RFQ 2023-002-1007
Hellen Haller Elementary School
Fire Alarm Replacement

Sequim School District #323

ADDENDUM 1

Issued: March 24, 2023

A4
 OF 8 SHEETS

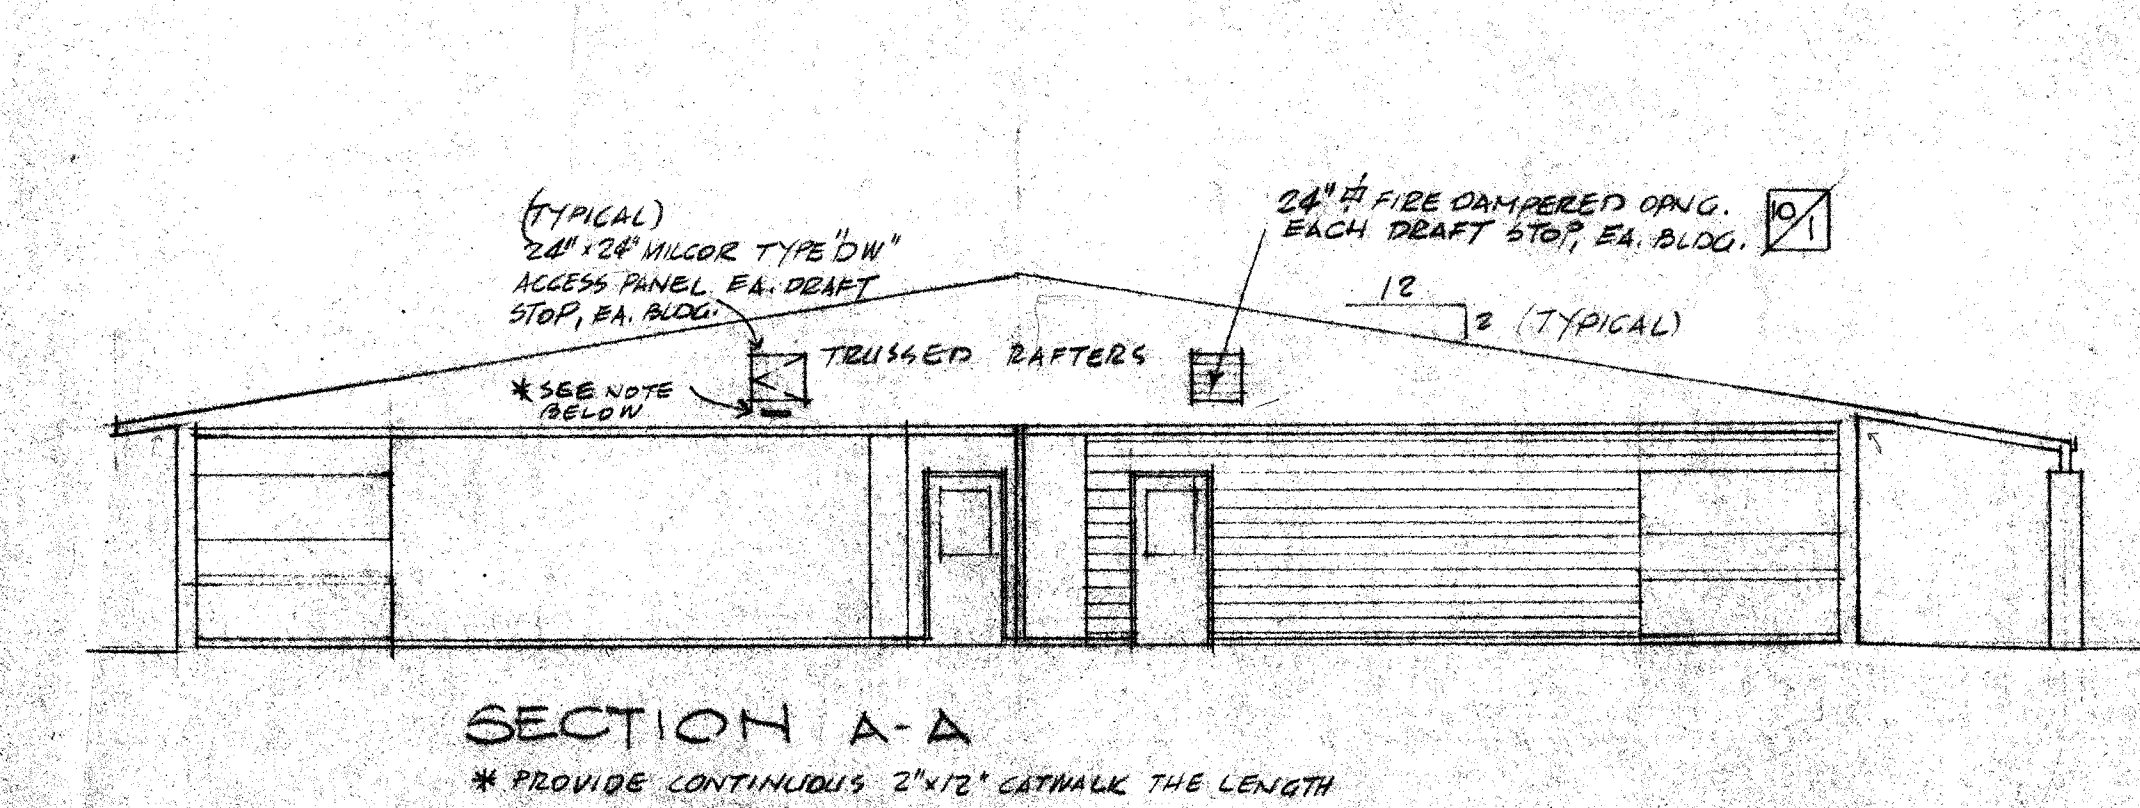
DRWG A4, Units B & C, Classrooms 5, 9, 10 and 14, provide "W" type furring behind sink unit BSE (1, 2 or 3 as it applies). Extend furring the length of casework and height to ceiling. Coordinate work with Mechanical Contractor and cover furring with gypsum wallboard taped and finished with enamel.

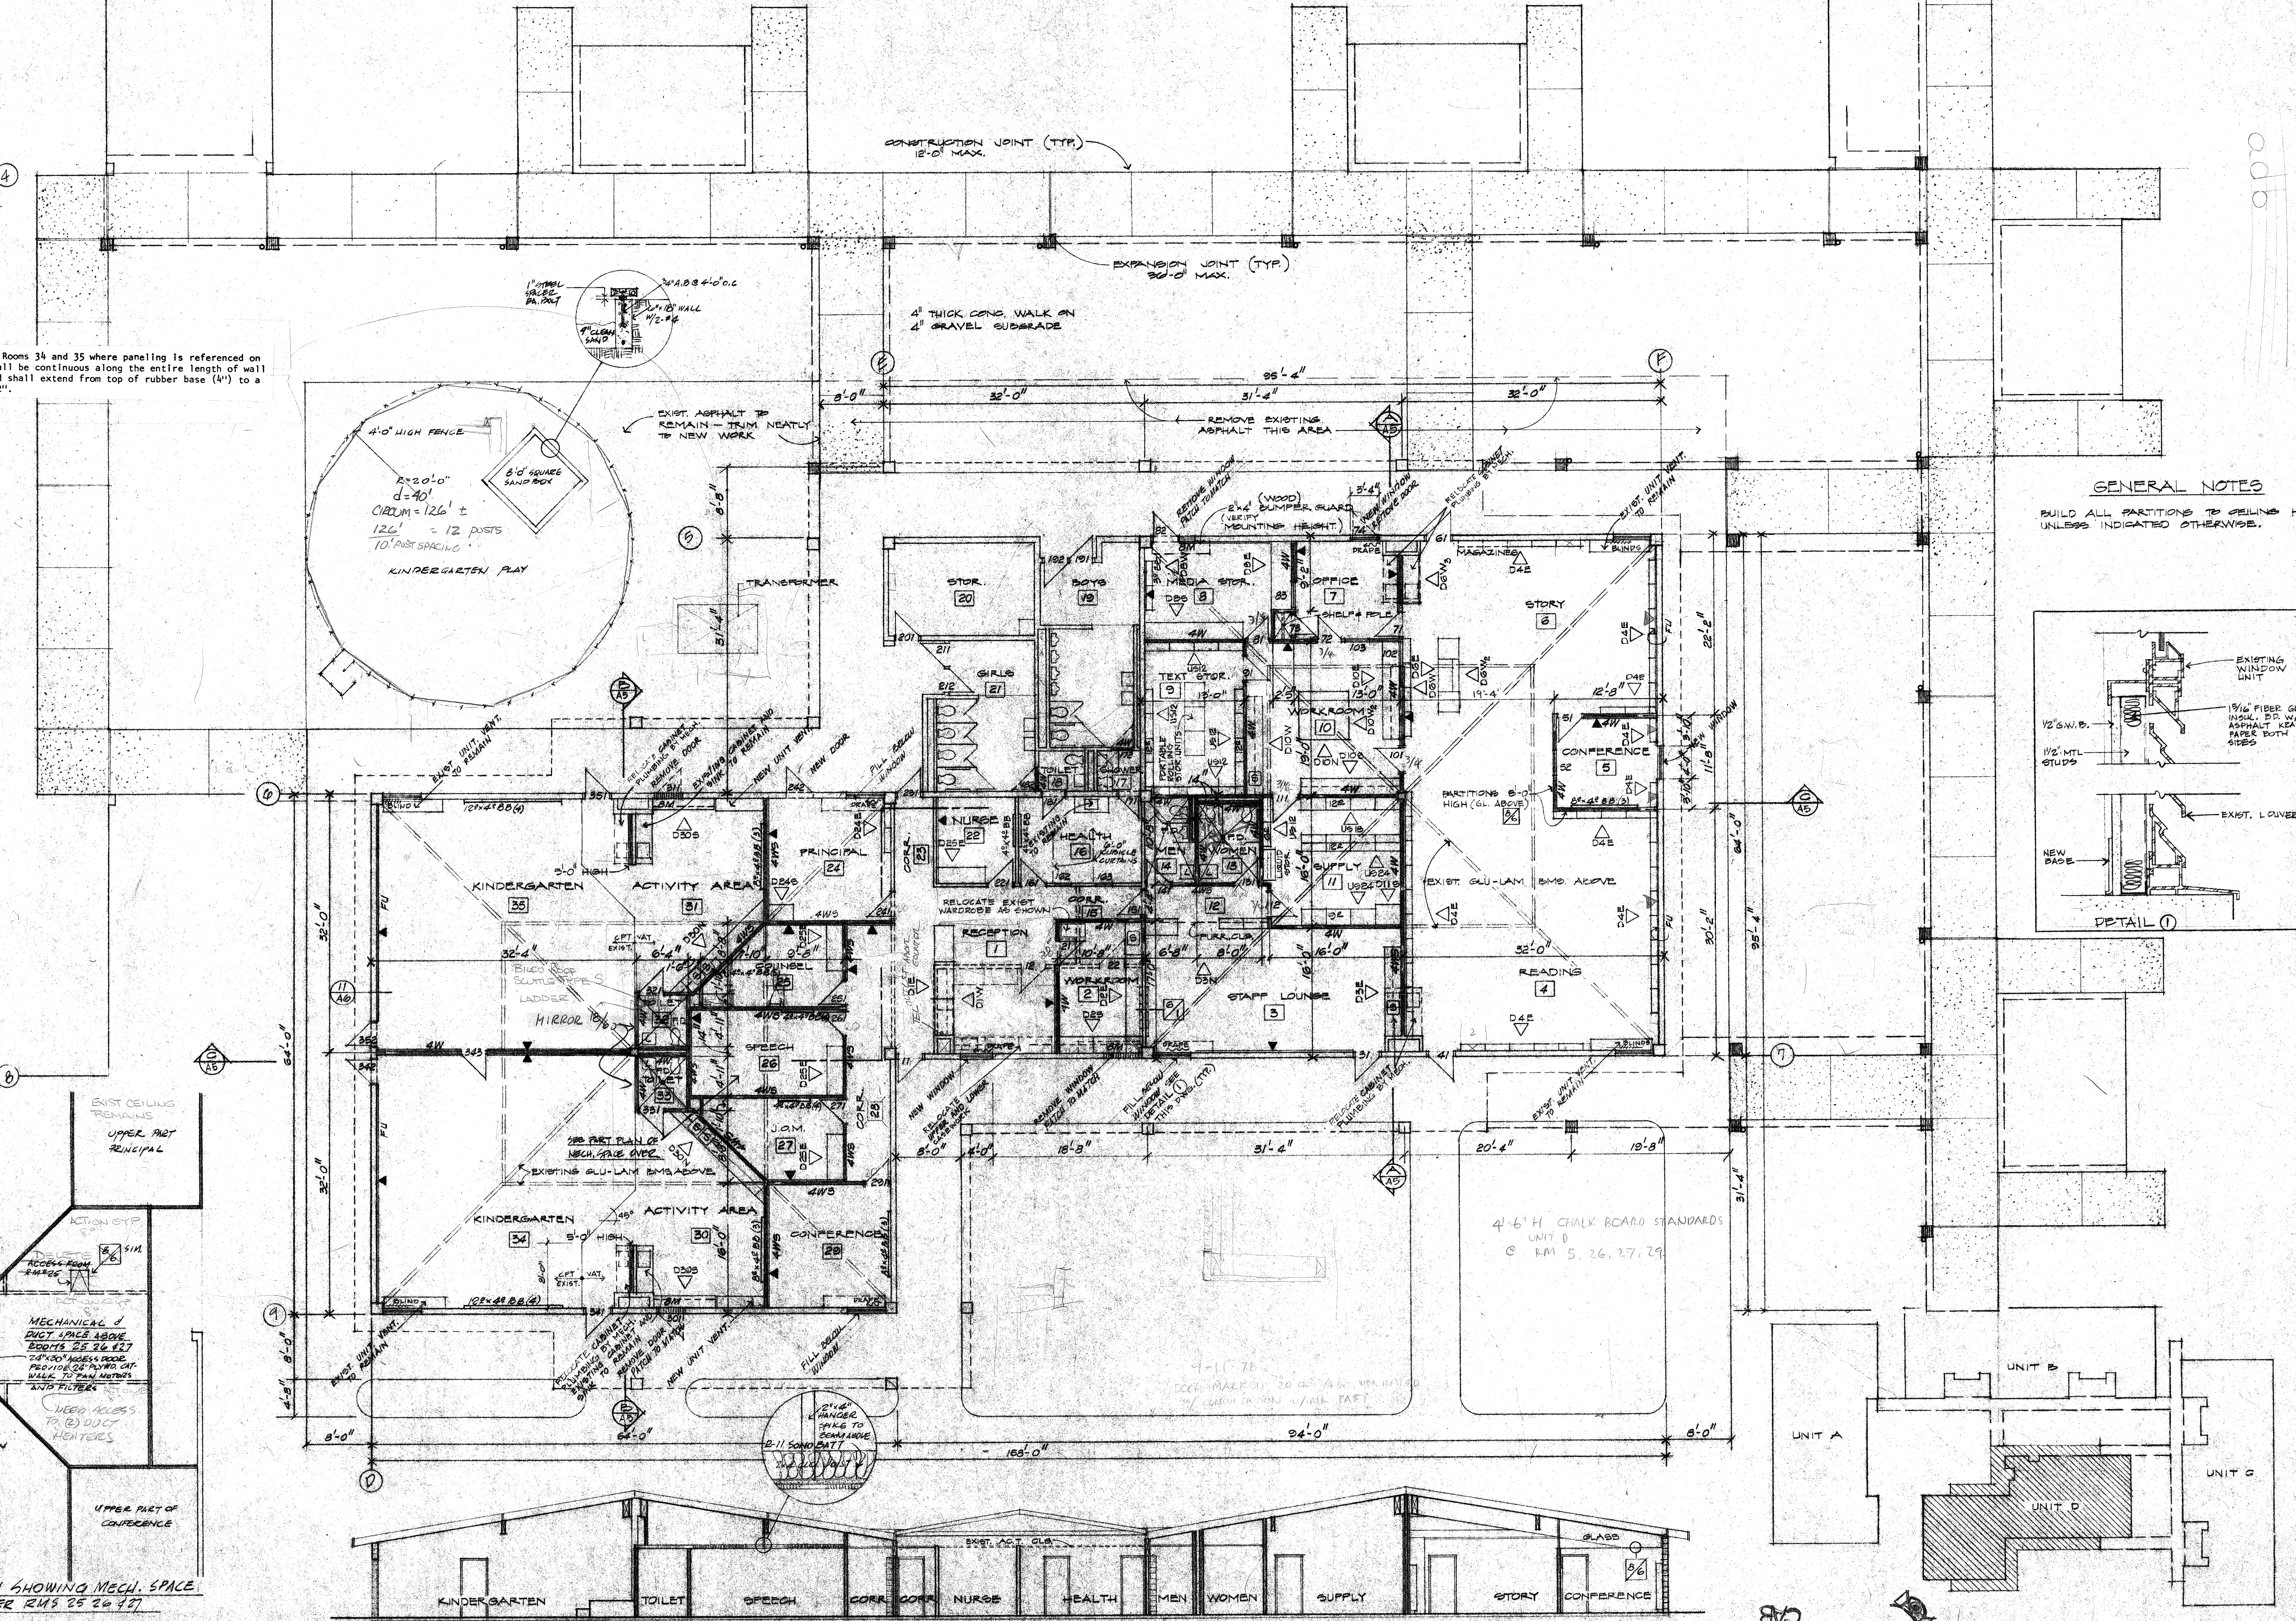
A5 Kindergarten Rooms 34 and 35 where paneling is referenced on walls, it shall be continuous along the entire length of wall indicated and shall extend from top of rubber base (1/4") to a height of 7'2".

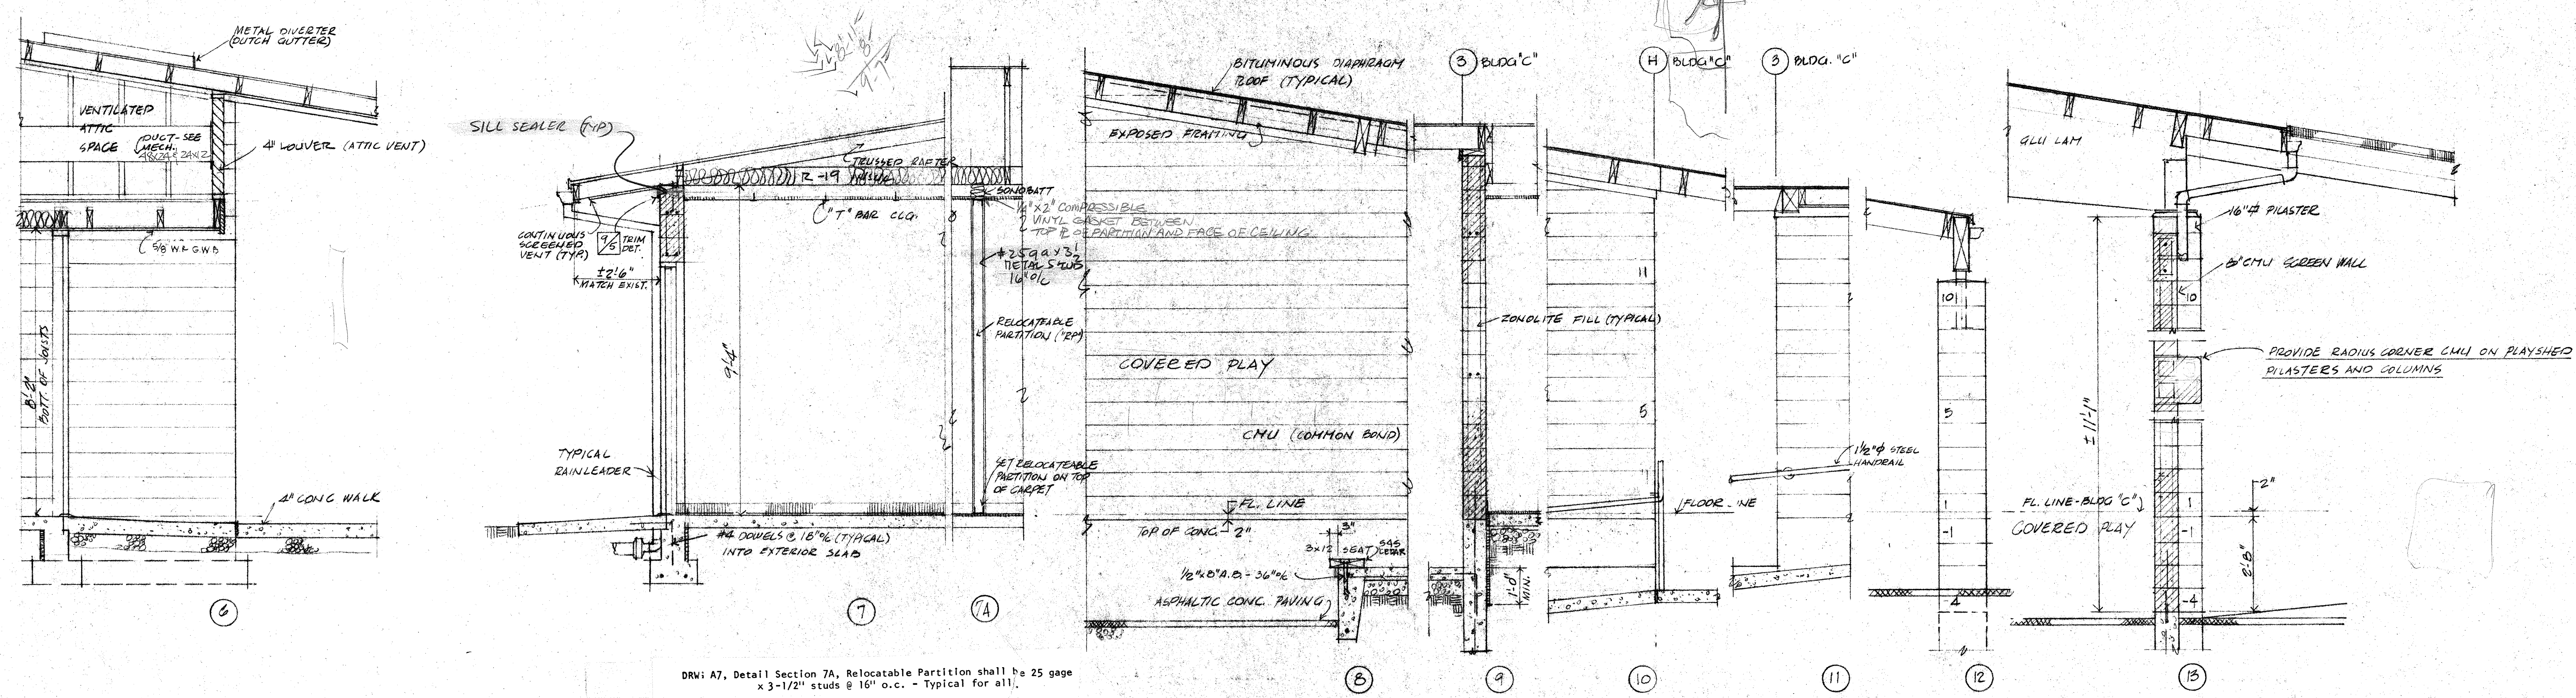
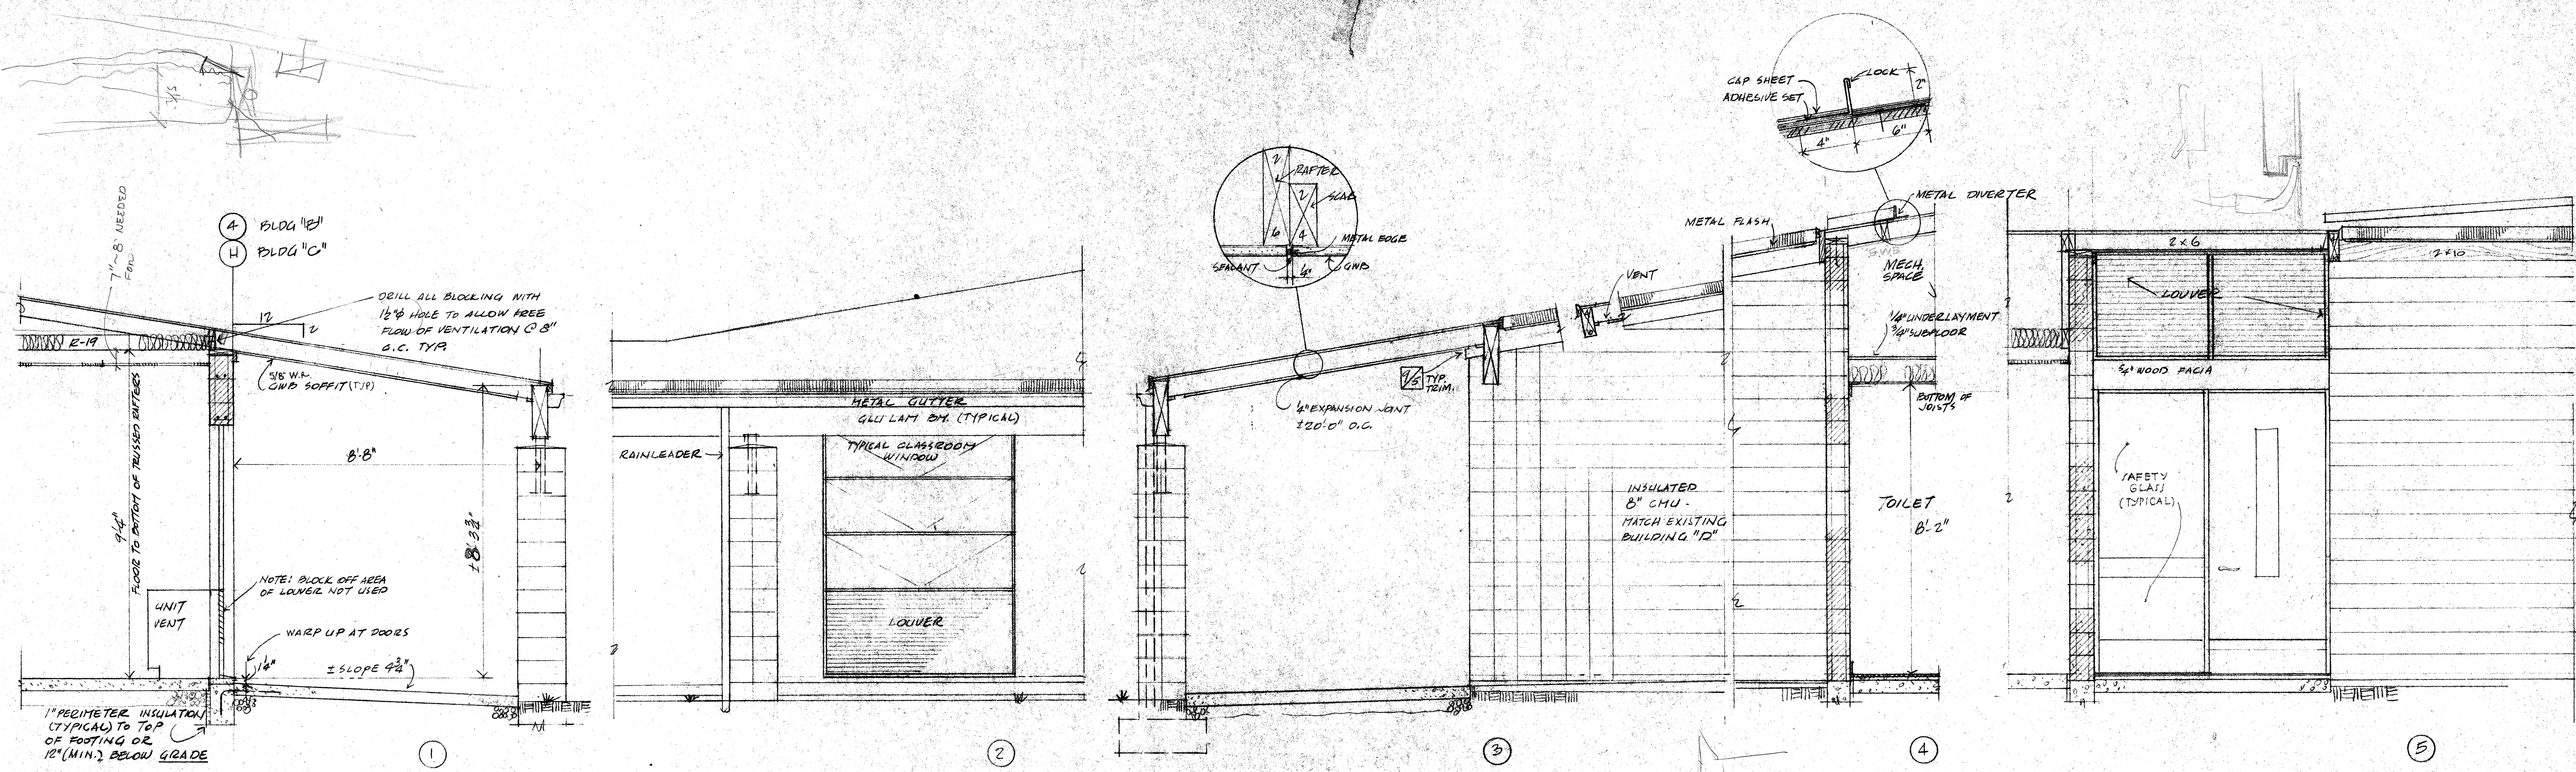
DRW: A7, Detail Section 7A, Relocatable Partition shall be 25 gage x 3-1/2\" studs @ 16\" o.c. - Typical for all.

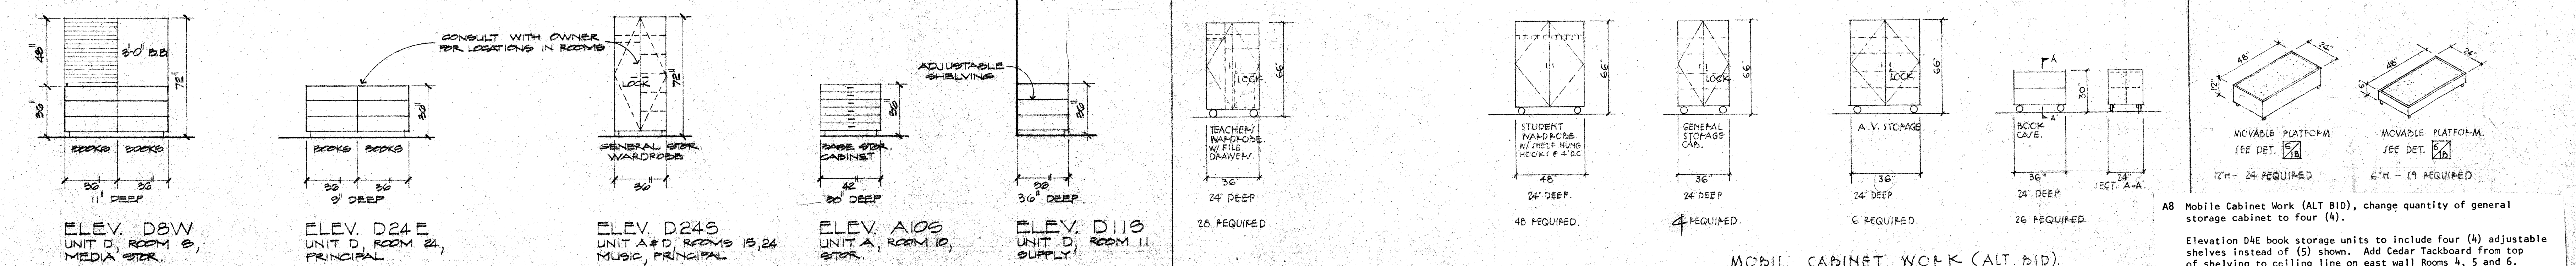
A8 Mobile Cabinet Work (ALT BID), change quantity of general storage cabinet to four (4).
 Elevation D8E book storage units to include four (4) adjustable shelves instead of (5) shown. Add Cedar Tackboard from top of shelving to ceiling line on east wall Rooms 4, 5 and 6.
 Elevation D10E and D10S. In each elevation delete one 36" base unit (with shelf) to provide knee space. Top is to be continuous.
 Elevation D30N (each room), wall mount upper cabinets shall extend continuously (approximately 12'0") above the full length of the base units.
